Well Name: COTTON DRAW UNIT	Well Location: T24S / R32E / SEC 34 / NESW / 32.172212 / -103.664653	County or Parish/State: LEA / NM
Well Number: 69	Type of Well: OIL WELL	Allottee or Tribe Name:
Lease Number: NMLC061936	Unit or CA Name: COTTON DRAW DELAWARE A	Unit or CA Number: NMNM70928B
US Well Number: 3002522294	Operator: CHEVRON USA INCORPORATED

Notice of Intent

Sundry ID: 2838965

Type of Action: Plug and Abandonment

**Proposed
WELLBORE DIAGRAM**

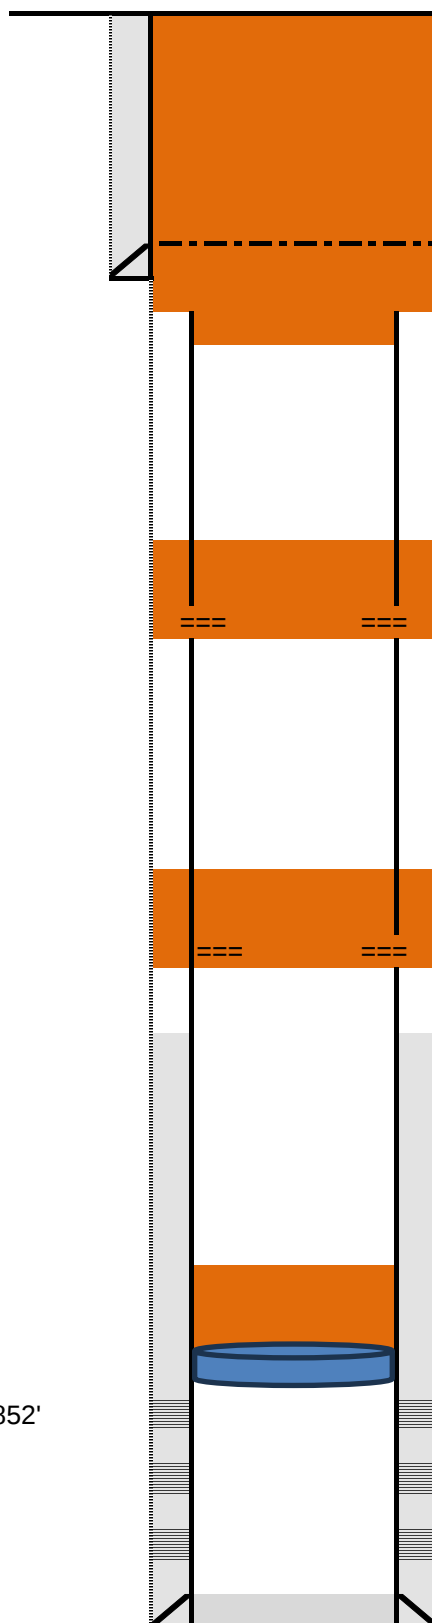
Plug Type	Top	Bottom	Length	Tag	Cement Class	Notes
Surface Plug	0.00	475.00	475.00	Verify Circulated to surface	CLASS C	Perf & Squeeze
7.625 inch- Shoe Plug	0.00	475.00	475.00			
Top of Salt @ 1190	1050.00	1250.00	200.00	WOC & TAG	CLASS C	Perf & Squeeze
Base of Salt @ 4510	4260.00	4760.00	500.00	WOC & TAG	CLASS C	500psi leak test 30mins
Delaware @ 4773	4260.00	4760.00	500.00			
CIBP Plug	4260.00	4760.00	500.00

Created By	Condition	Condition Date
gcordero	Spot cement plug across cut casing 50' below to 50' above cut.	4/2/2025
gcordero	A Cement Bond Log (CBL) is required to be submitted to electronic permitting.	4/2/2025
gcordero	Submit Cement Bond Logs (CBL) prior to submittal of C-103P.	4/2/2025
